SERVICETEKNOTES

TABLE OF CONTENTS

S-3200 DC SUBSYSTEM OSCILLATION

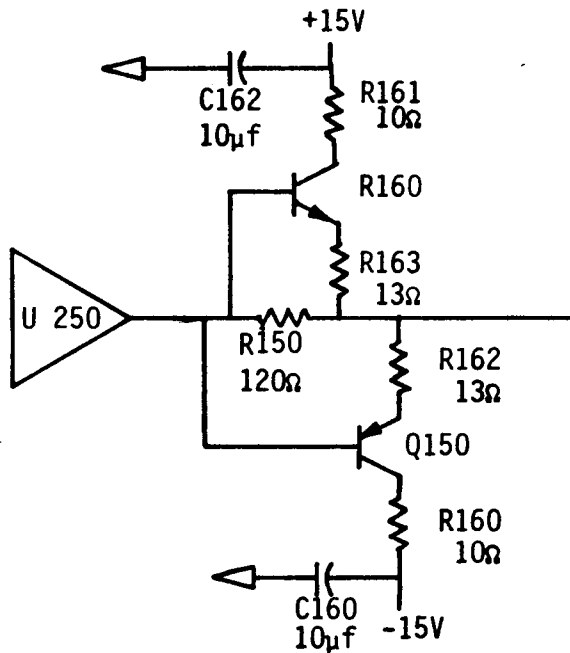
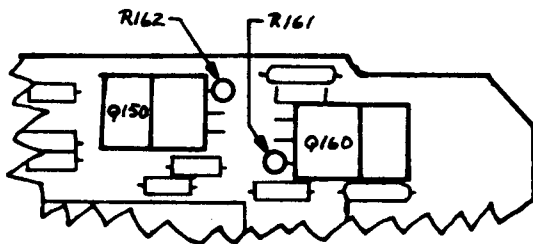
The DC Subsystem amplifier oscillates at about 10 MHz. This occurs while measuring current on the 100 ma range with VS3 or VS4 set greater than + or - 1.8 volts and with a load of about 100 ohms from I pin to system ground. The oscillations are enveloped by about a 60 Hz rate on domestic systems. The problem is sensitive to common bus capacitance and has mostly been seen on systems with CF-1. In order to see the problem on systems without CF-1, it is sometimes necessary to add several feet of cable (capacitance) in the common bus line. The following paragraph and circuit view describe how the circuit is to be modified to significantly reduce the oscillations.

Change Q150 from a 151-0364-00 to a 151-0366-00. This will make a better match of Q150 and Q160. Change R150 from 47 ohm, 1/4W, 5%, 315-0470-00 to a 120 ohm, 1/4W, 5%, 315-0121-00. Add R162 and R163 resistors 13 ohm, 1/4W, 5% 315-0130-00. This will dampen the oscillations

which are caused by the cascaded emitter follower (U250, Q150, and Q160 connections).

Change DC Subsystem amplifier schematic as shown below:

Install R161 & R162 on DCSS Amplifier as shown below

TM5003/TM5006 OSCILLATOR I.C.
REPLACEMENT OR OSCILLATOR FREQUENCY
INCORRECT

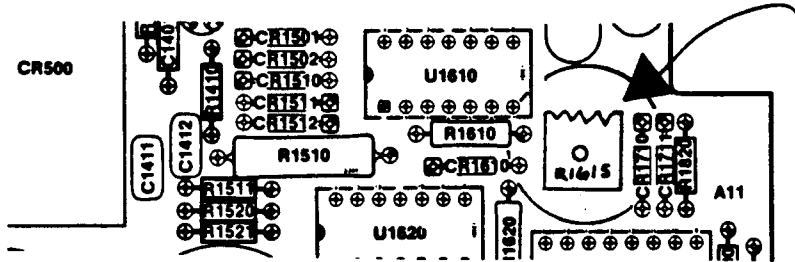
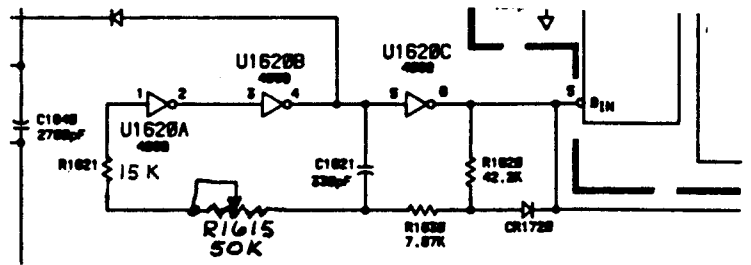
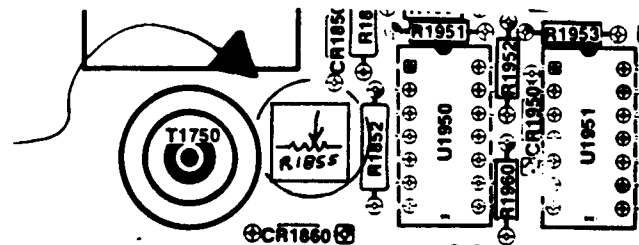
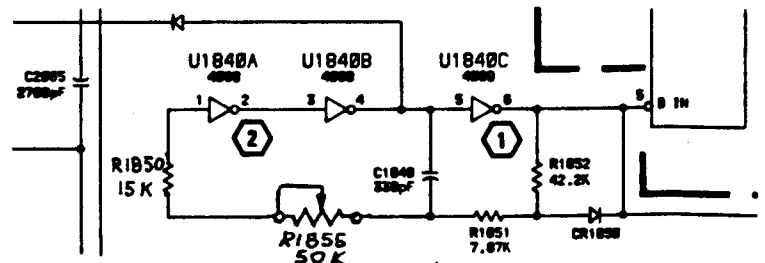
Damage can occur to the switching transistors Q1300 or Q1301, TM5003, (Q1640 or Q1650, TM5006) if the oscillator frequency of the TM5000 mainframe does not meet the 40 kHz to 42 kHz specification as tested at R1510 (R1860). A symptom of an audible high pitch noise indicates

the oscillator is off frequency. Batch variances of the oscillator I.C. U1620 (U1840) P/N 156-0745-00 can cause the oscillator frequency not to meet specification. If it is determined the frequency is not correct or when replacing U1620 (U1840) the following changes should be made.

1. Change A11R1621 (R1850) to P/N 321-0306-00 15K ohm 1/4W
2. Remove A11W1630 (W1860) Dummy Resistor
3. Add A11R1615 (R1855) P/N 311-1232-00 50K ohm var. resistor.

The holes provided for the var. resistor are located above the removed dummy resistor. Caution, the holes provided are not the holes left by the removal of the dummy resistor, but are holes already provided for the variable resistor. The part is keyed to be inserted only one way (see diagram for the part location).

Figure 1
SAFETY LABELS

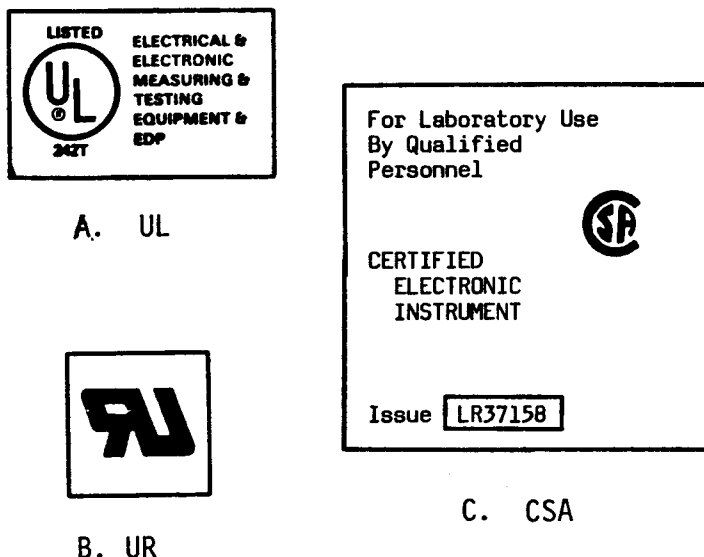
Starting at B010180 (690SR) or B010647 (6942) several labels have been added to the mainframe. Figure 1 illustrates the three safety certification labels that will be used. Labels 1A & C will be found on 690SR instruments in most applications, and labels 1B & C will be found on 6942 instruments and some 690SR options.

Figure 3

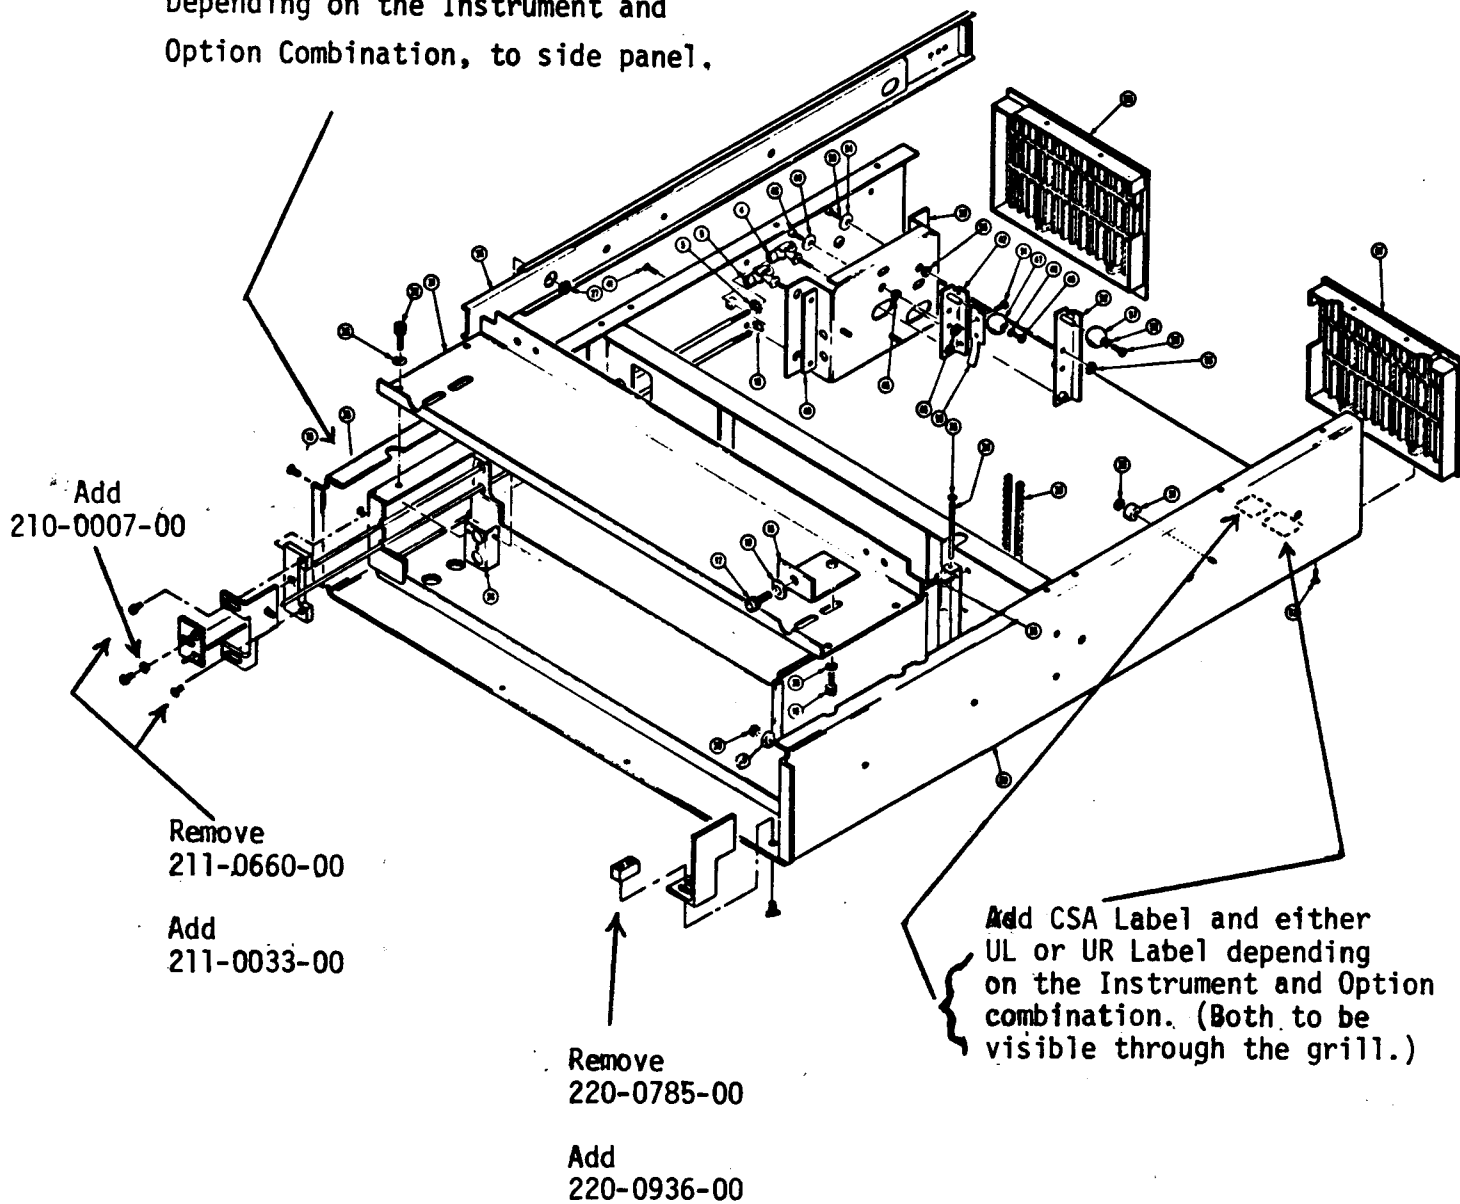
These labels are located at the rear of the bottom chassis as per Figure 3. These labels are not field replaceable. If one of these labels is damaged and must be replaced for customer requirements, the instrument must be returned to the factory. Contact Factory Service and arrange for the instrument to be sent in for recertification on the manufacturing line.

Figure 2 illustrates two labels, one of which will be located on the Front left side of the bottom chassis as per Figure 3. Label 2A will be installed on 690SR's sold into the television marketplace, and label 2B will be installed on 690SR's installed in data display applications, particularly Opt. 40 and 48. These labels call out the appropriate Horizontal scan rate for instrument calibration.

FIGURE A

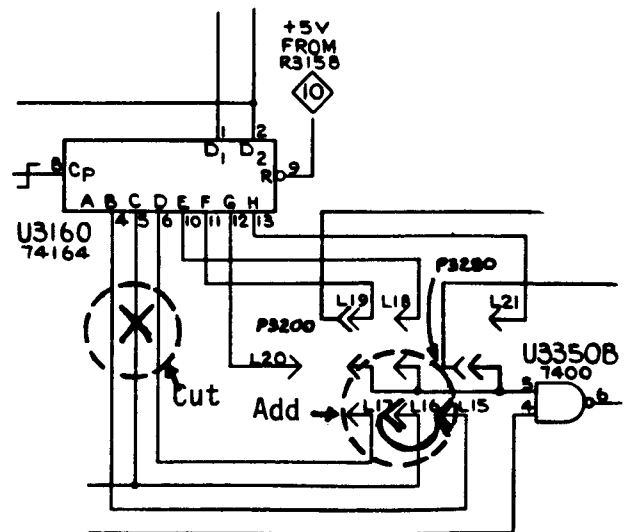
Vertical insertion width adjustment can be modified to allow passage of lines 15 and 16 by replacing R7200 with an 18.2K ohm resistor, and then

Figure A illustrates the modification for setup timing, and figure B illustrates the modification for insertion timing.
